**KAWARTHA PINE RIDGE DISTRICT SCHOOL BOARD
PUR24-087-ITT
Clarke High School Classroom Refresh**

ADDENDUM NO. 2

**BARRY BRYAN
ASSOCIATES**

Project No.: 24035
Date: May 9, 2024
Tender No.: PUR24087-ITT
Project: **RECONFIGURATION CLASSROOMS AT CLARKE HIGH SCHOOL**
Kawartha Pine Ridge District School Board

1.1 DRAWING SHEET A204 PART SECOND FLOOR DEMOLITION PLAN

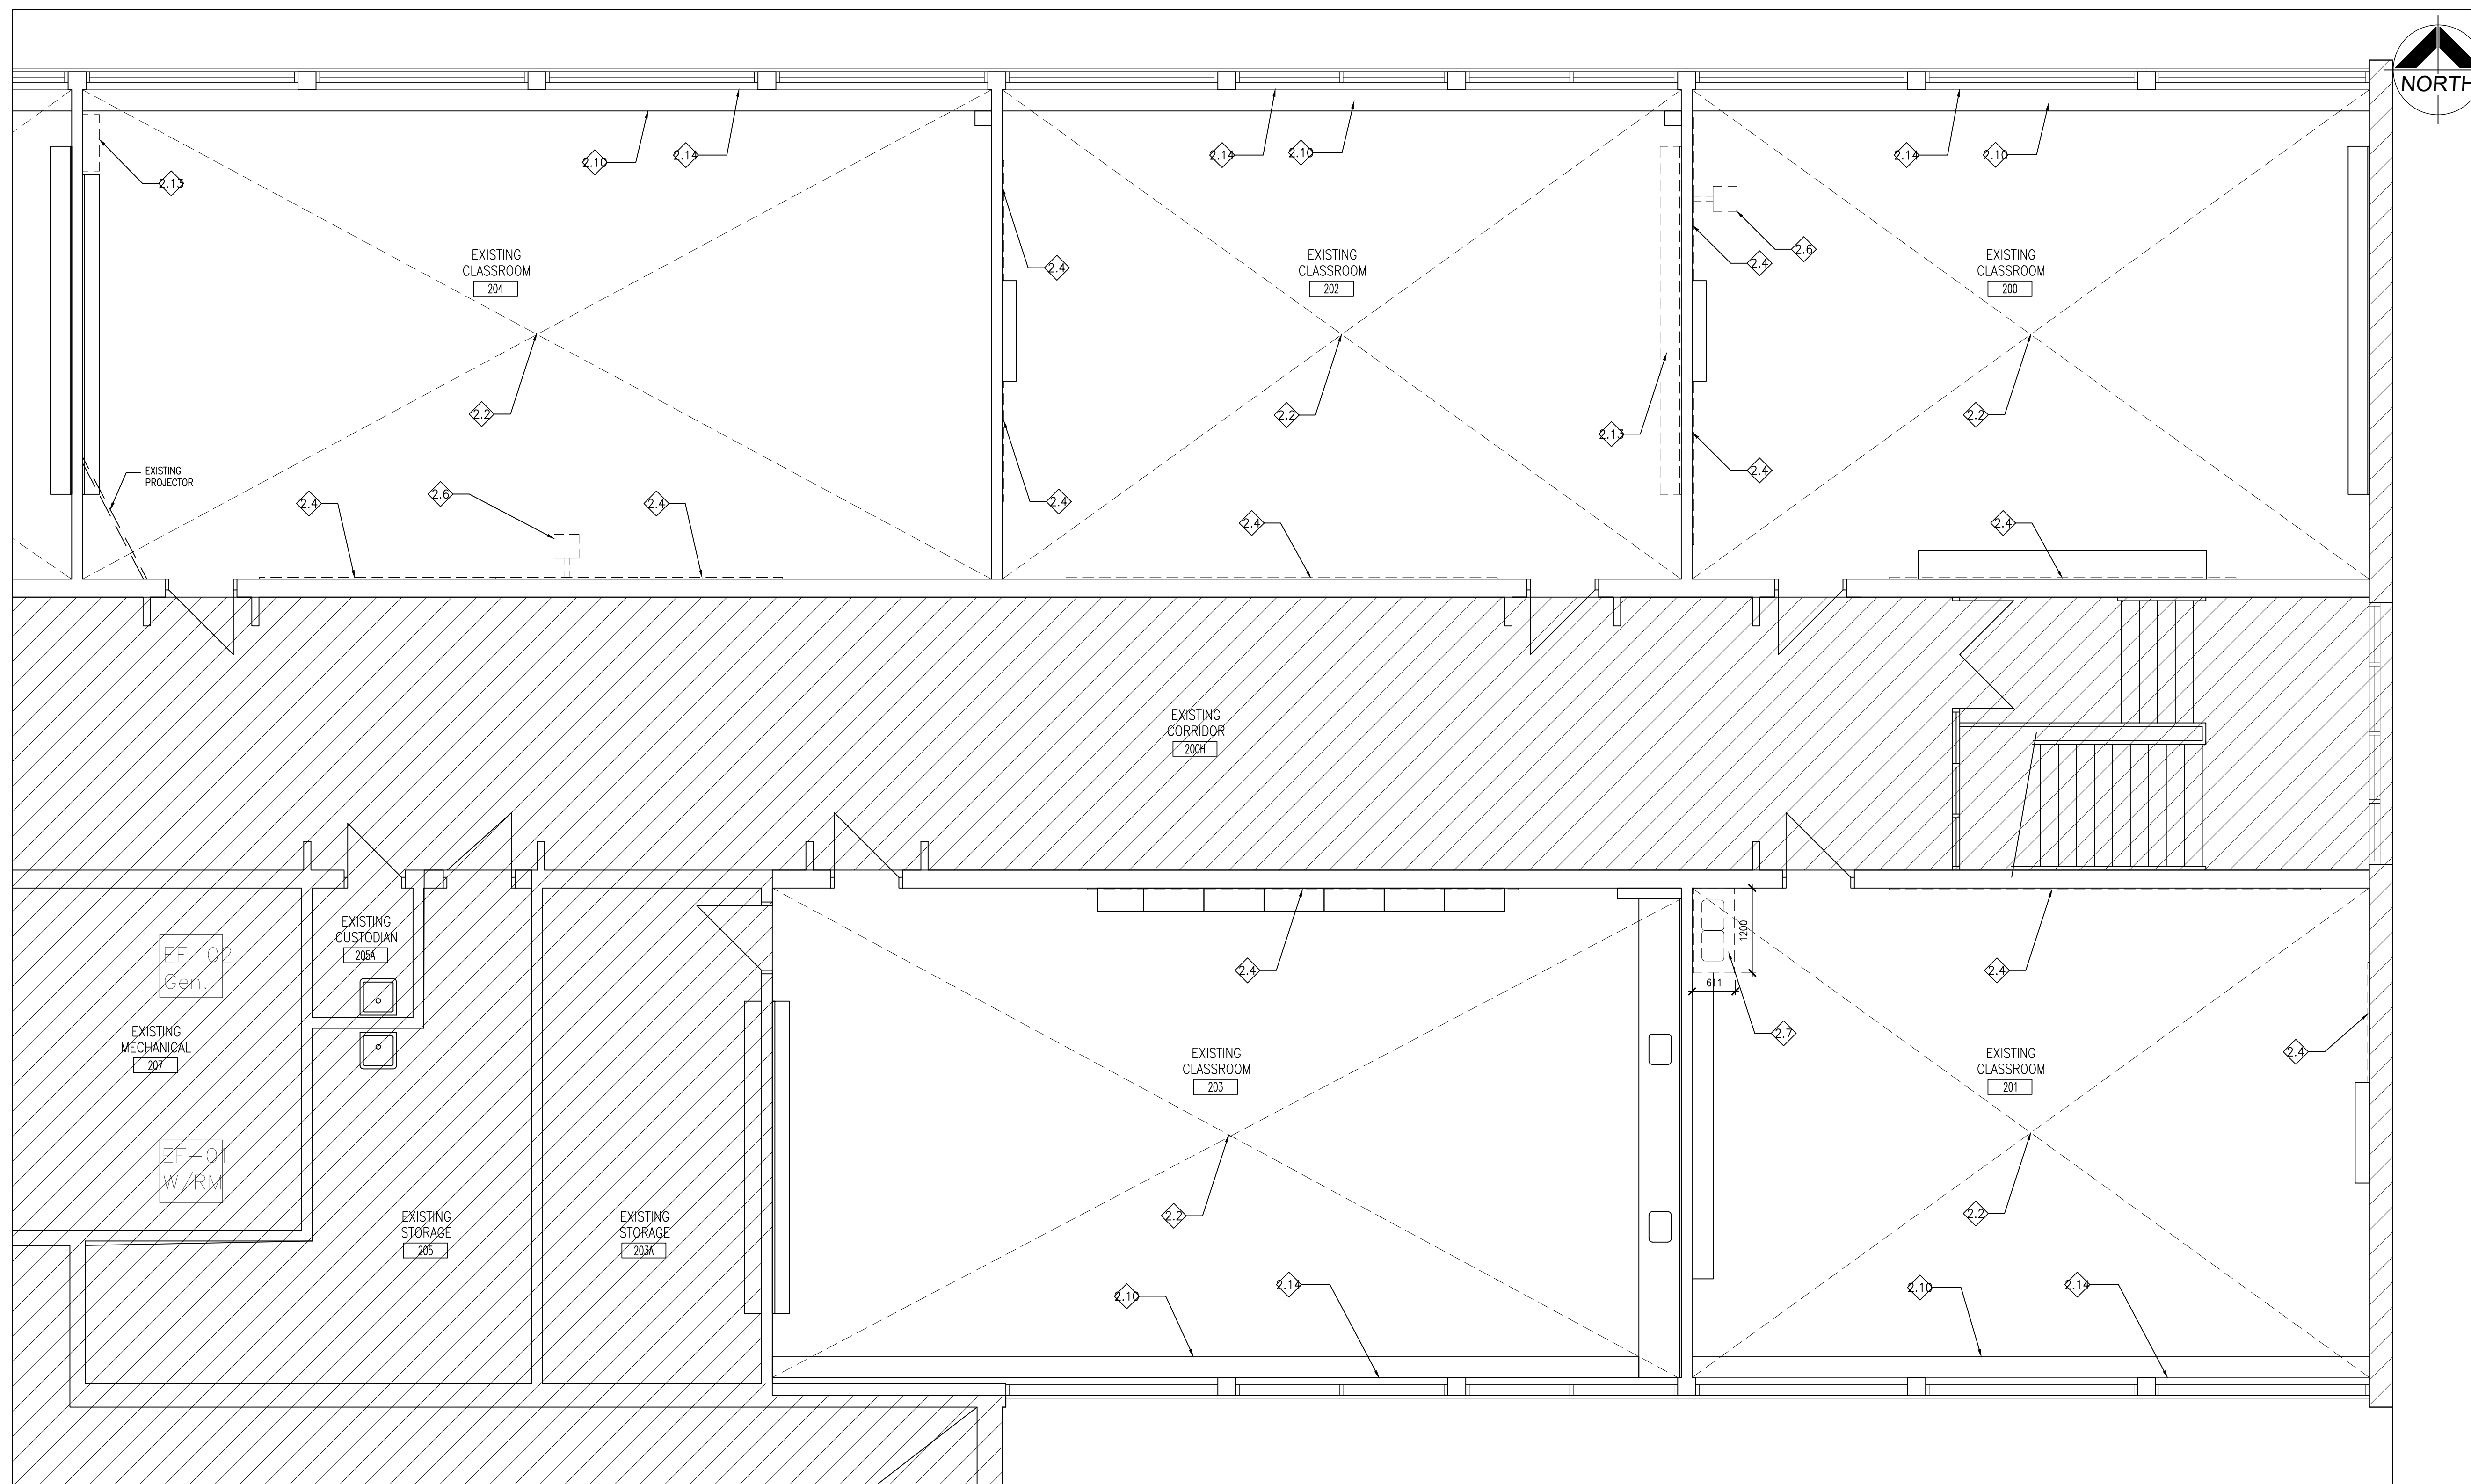
- .1 Revised Note 2.13.
- .2 Added Note 2.14.

1
A207 PART FIRST FLOOR PLAN (102 & 100A)
1:50

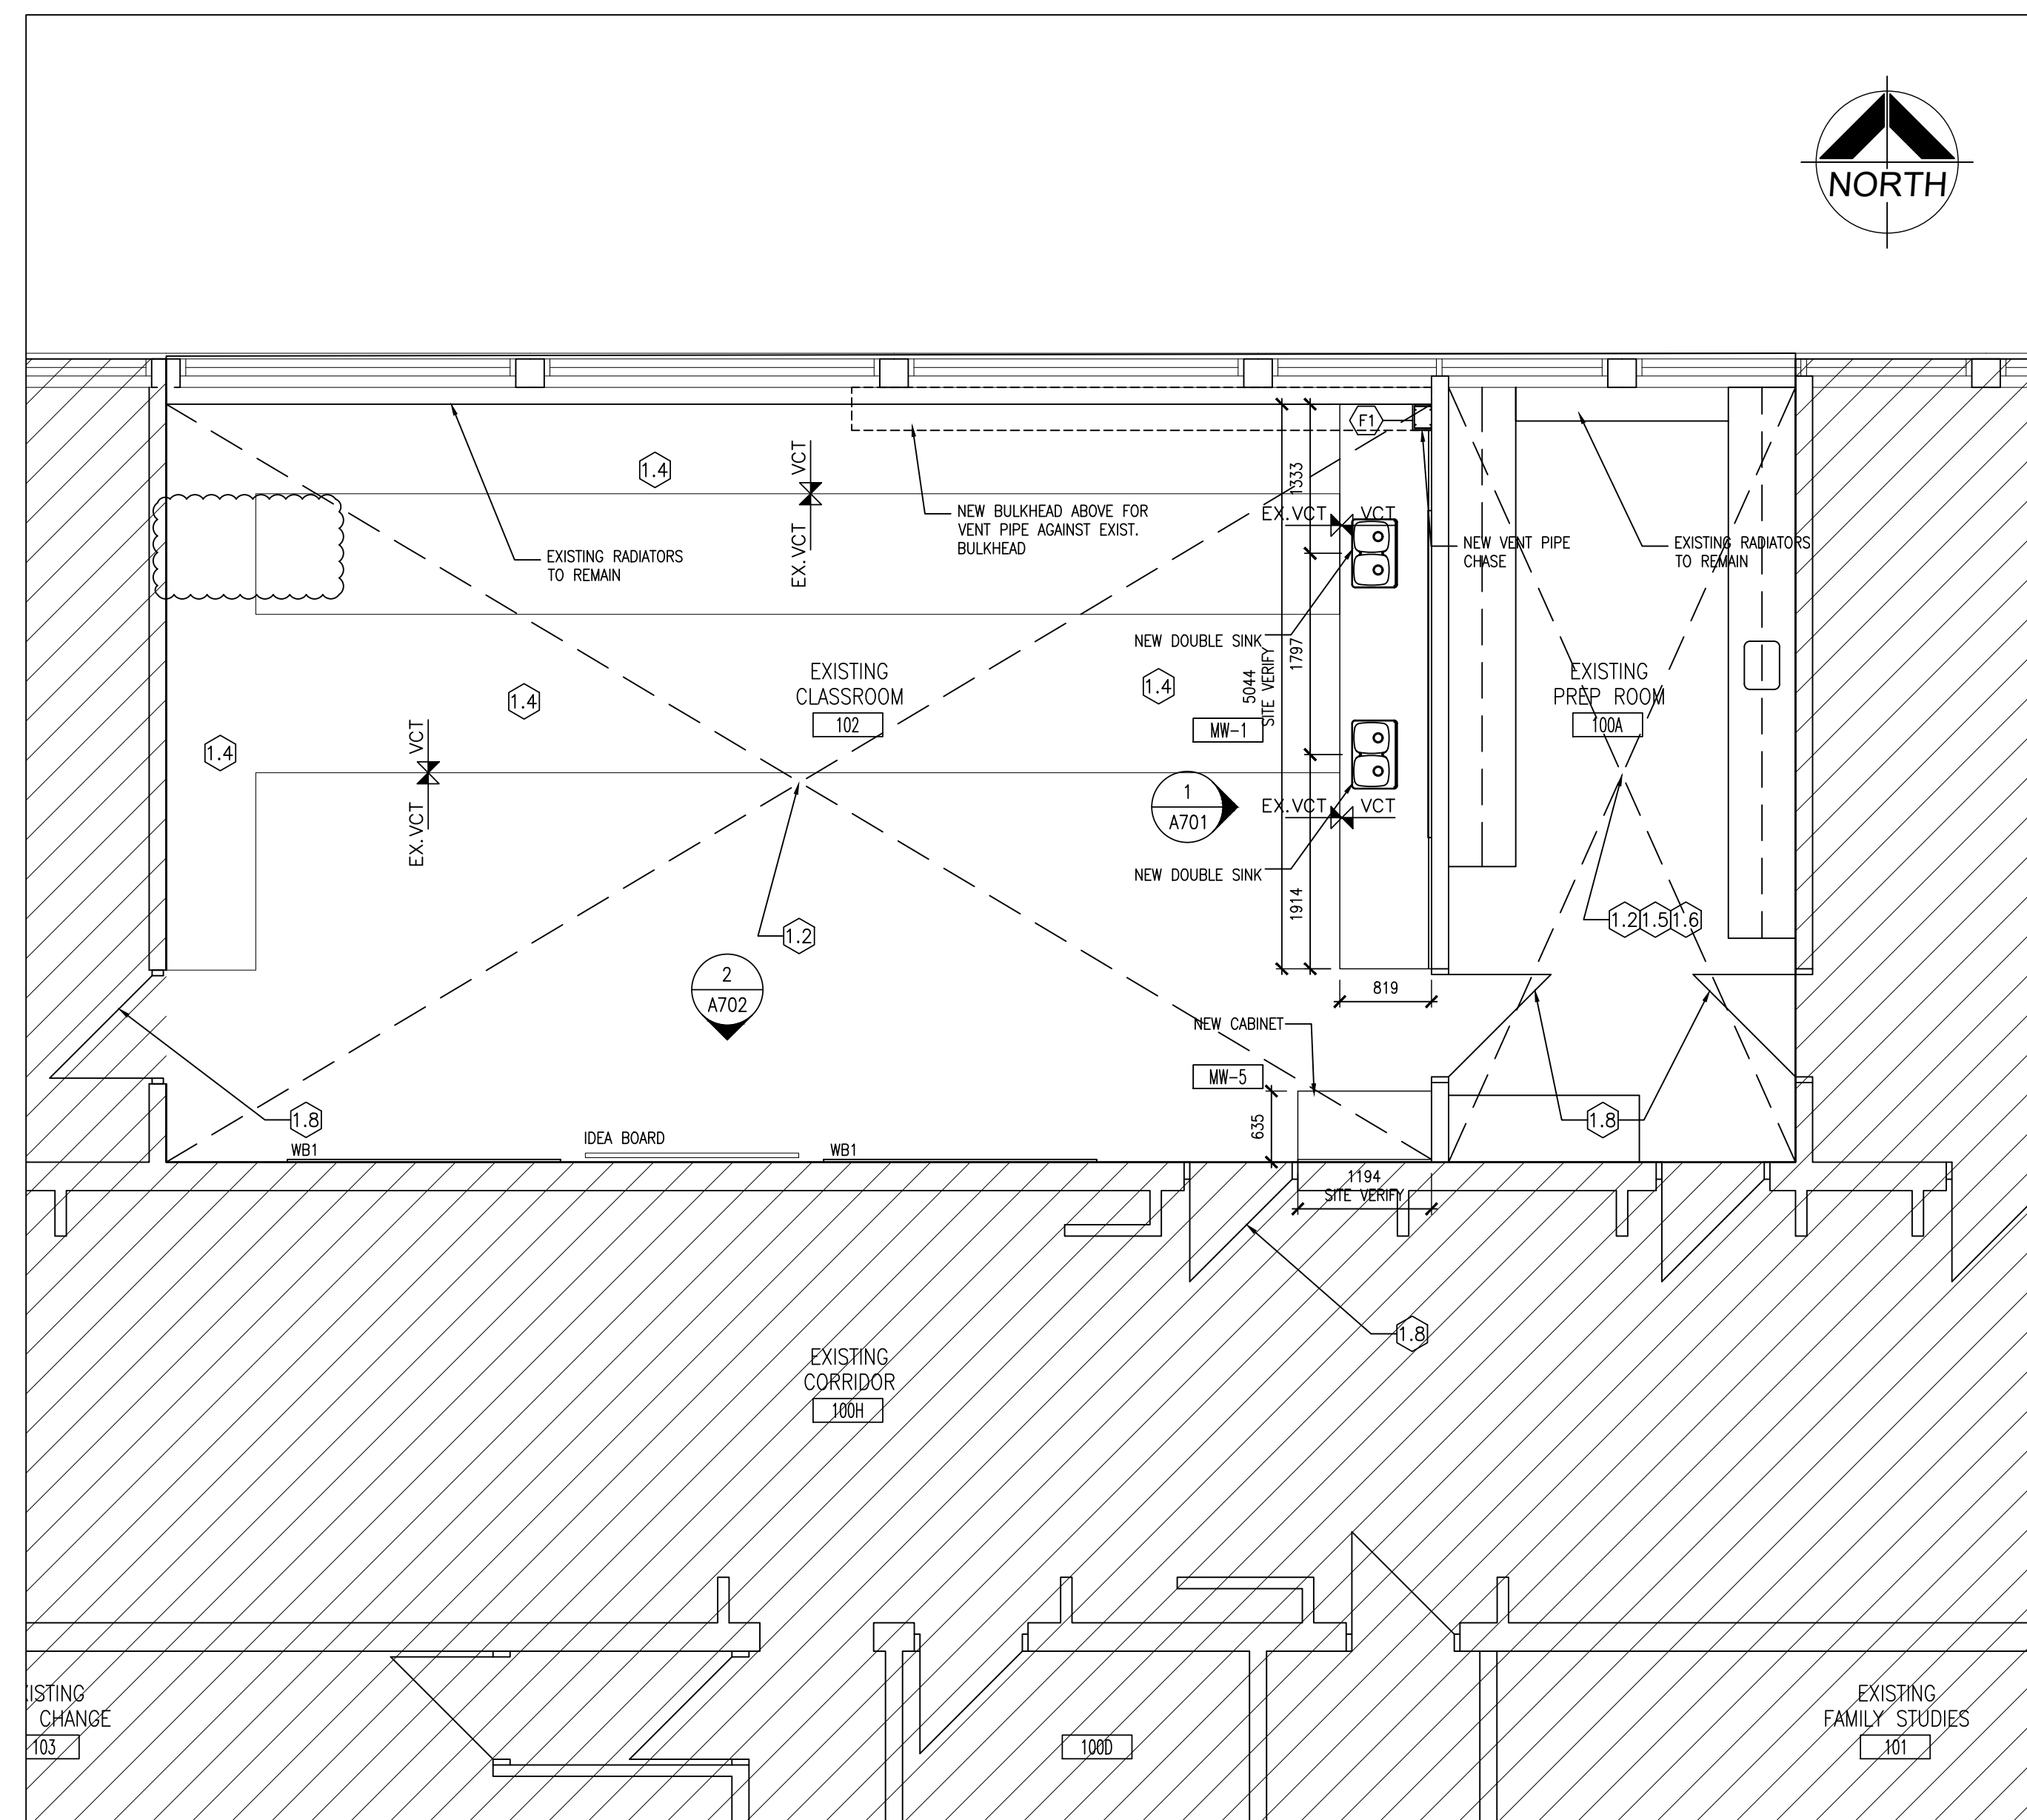
- .1 Revised extent of VCT replacement 1/A207. Provide new VCT As per plan and at locations of existing millwork.

2
A207 PART FIRST FLOOR PLAN (DOOR 100)
1:50

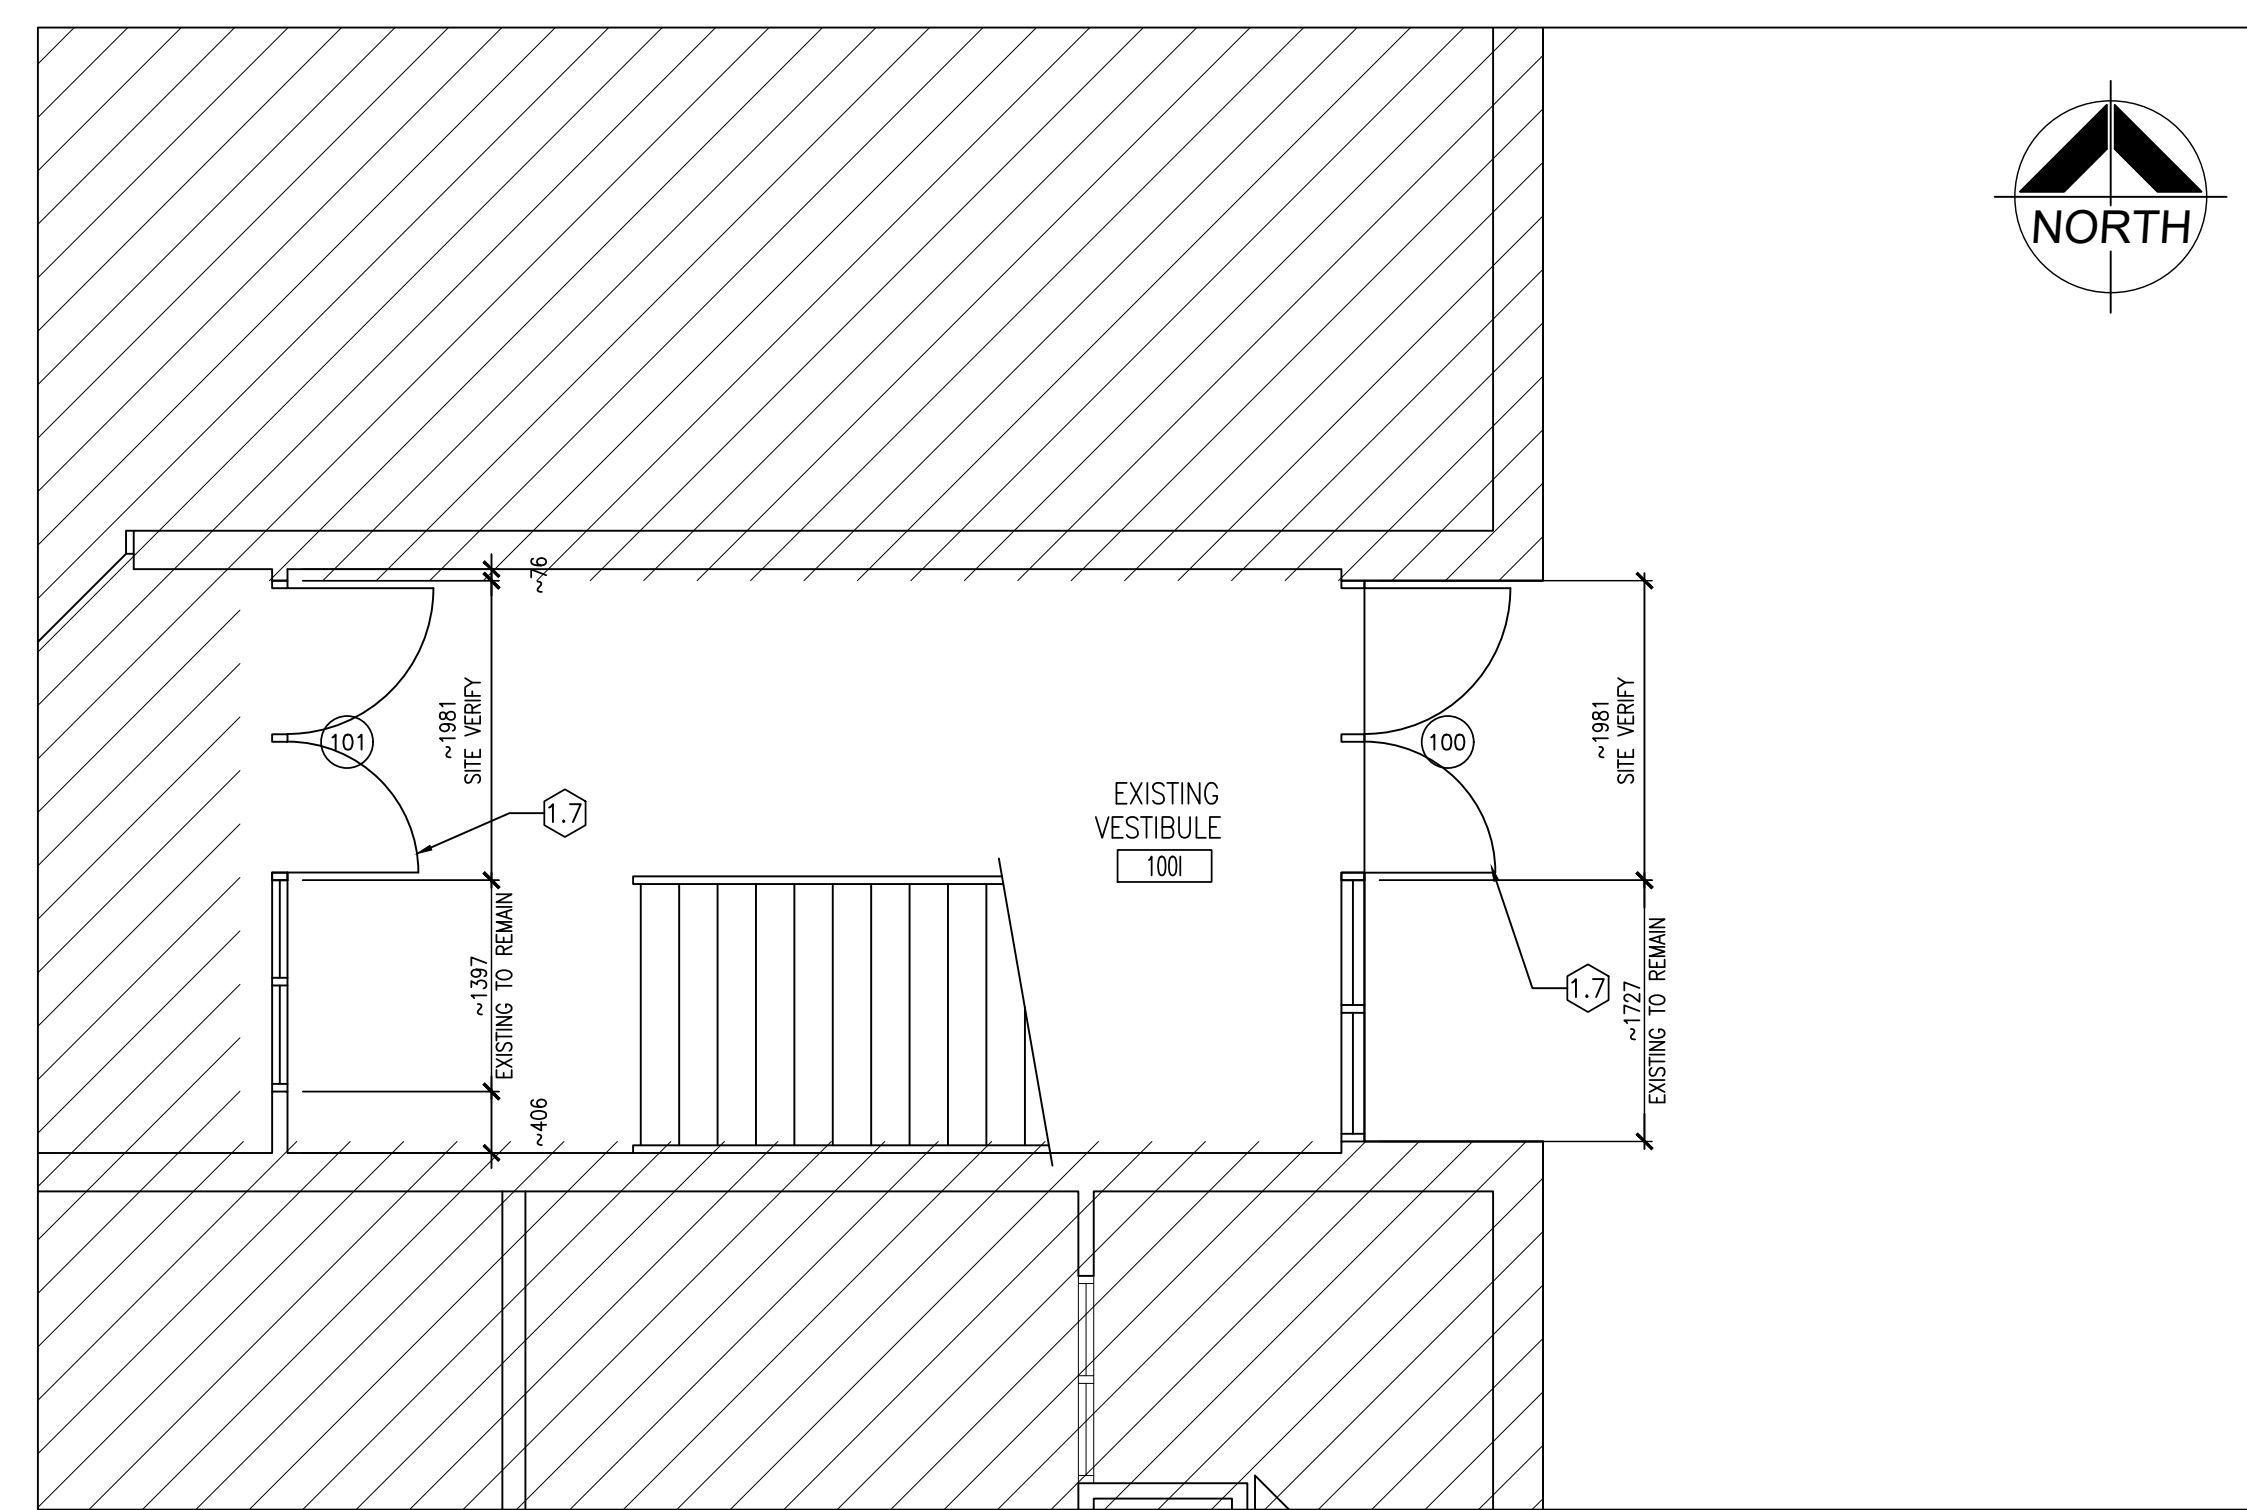
1.8 **Question:** **2/A207- states to provide new doors, demo notes to remove doors and frames. Door 101 is Hollow Metal Doors and Frames and Door 100 is Aluminum Doors and Curtainwall. Please confirm scope- are we to remove existing doors and install new doors to meet barrier free requirements and 2 new removable mullions?**

Answer: *Remove existing doors and install new doors to meet barrier free requirements with 2 removable mullions. Provide paint finish to match existing for both existing frames.*
